ADA PARKING LOT SPATIAL REQUIREMENTS
DUNBAR NEIGHBORHOOD FACILITY
EROSION CONTROL

17. DUNBAR NEIGHBORHOOD FACILITY

ADA PARKING LOT SPATIAL REQUIREMENTS
DUNBAR NEIGHBORHOOD FACILITY
LOCATION MAP AND DOJ COMMENTS

17-01

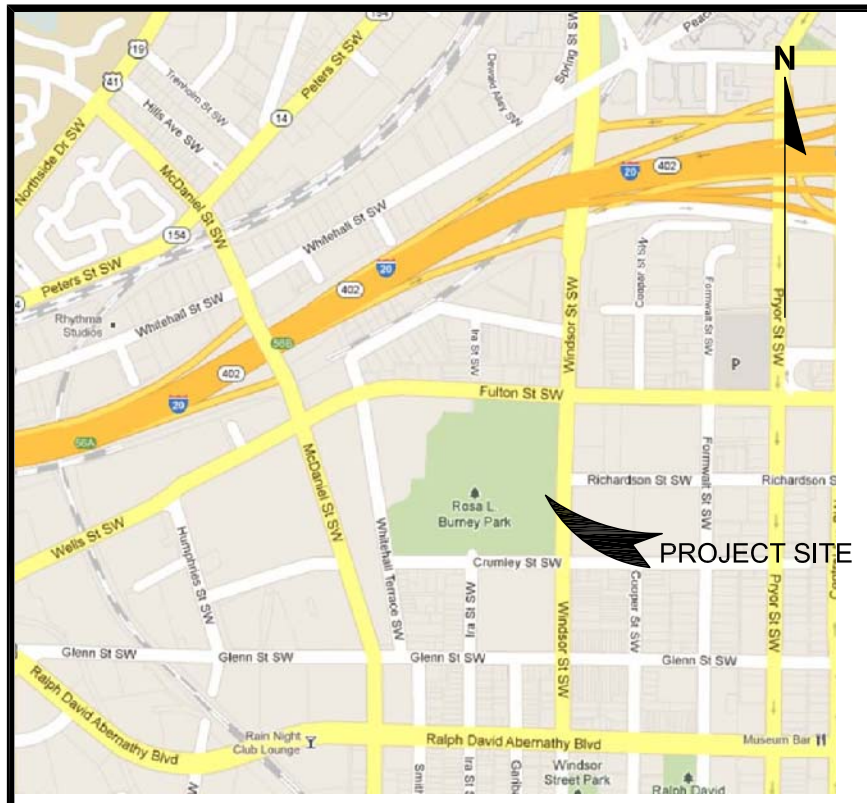
Reference # 17
Name **Dunbar Neighborhood Facility**
Item # 1.1
Access Issue Parking Lot. The parking lot, with a total of 106 parking spaces, has only 4 designated accessible parking spaces, the designated accessible parking spaces have no vertical signage and no access aisles, and one of the designated accessible spaces ha a cross slope of 3.4%. This lot requires 1 van accessible space and 4 standard accessible spaces.

On the shortest accessible route to the accessible entrance, provide accessible parking designated as reserved for people with disabilities, including van accessible spaces and standard spaces, as required in the following chart. Ensure that standard accessible spaces are a minimum of 96 inches wide and served by access aisles at least 60 inches wide. Ensure that van accessible spaces are a minimum of 96 inches wide and served by access aisles at least 96 inches wide. At all spaces designated as reserved for persons with disabilities, provide vertical signs with the International Symbol of Accessibility located such that they cannot be obstructed by parked vehicles. At van accessible spaces, provide an additional "Van-Accessible" sign located below the International Symbol of Accessibility. Ensure that all spaces and access aisles for persons with disabilities are flat and level, with slopes and cross-slopes not exceeding 2% in all directions, and that their surfaces are firm, stable, and slip-resistant. If the parking facility does not serve a particular building or facility, provide accessible parking on the shortest accessible route to an accessible pedestrian entrance of the parking facility. If the parking facility serves a building with multiple accessible entrances or multiple buildings or facilities, provide dispersed parking spaces located on an accessible route closest to the accessible entrances. If the parking facility is a parking garage or otherwise has limitations on vertical clearances, provide minimum vertical clearance of 98 inches at the van accessible parking spaces and along at least one vehicle access route to such spaces from site entrances and exits. Standards §§ 4.1.2(5), 4.6, 4.30.7(1).
